Response to Arborist Comments

August 16, 2021

Bone Structure	Owner:	Vista del Valle LLC
156 Second Street, Suite 307	Permit Address:	16461 South Kennedy Road
San Francisco, CA 94105	Application #	S-18-043
(650)660-0434	Project:	Vista del Valle Residence
aazaren@bonestructure.ca

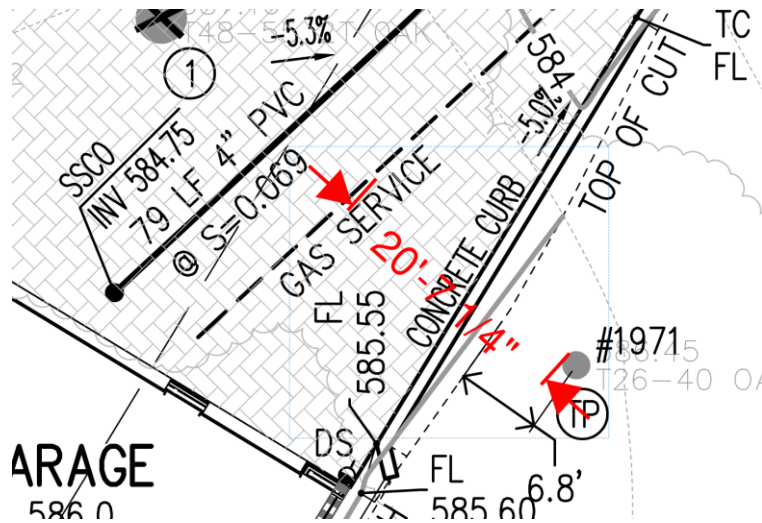
a. Water, Gas, Sewer Service Trench Alignments On-Site: It is suggested that the project team “finalize” the alignments of the proposed utility trenches, such that trench side walls are at least 20 feet offset from the trunk edges of trees #1971, 1973, and #1974. These alignments are not shown completely on PDF plan sheet 26 of 29 grading and drainage version December, 2020. An offset of 20 feet from tree trunk edges would be ideal. Toward this end, it is suggested that:

- i. Gas and sewer pipe routes be pushed to underneath the driveway footprint such that they remain 20 feet or greater offset distance from tree #1971.

Response: The gas and sewer routes have been pushed toward the center of the driveway to offset the distance from tree #1971 of 20 feet or greater. See screenshot below.

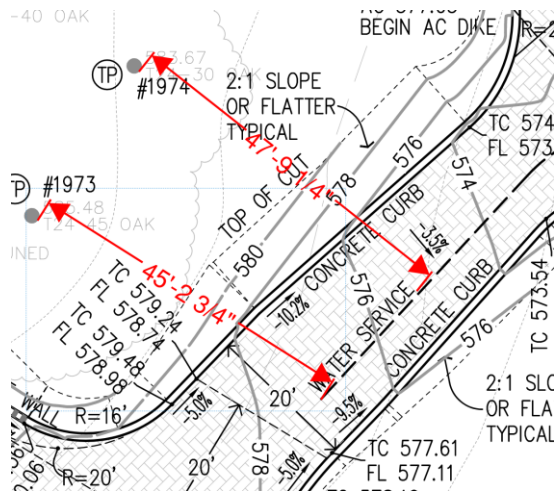
- ii. The water pipe route be tightlined against the new fire truck driveway footprint, to maximize root preservation around trees #1973 and #1974.

Response: The water line has been moved so that there is a distance of more than 45 feet from trees #1973 and #1974. See screenshot below.
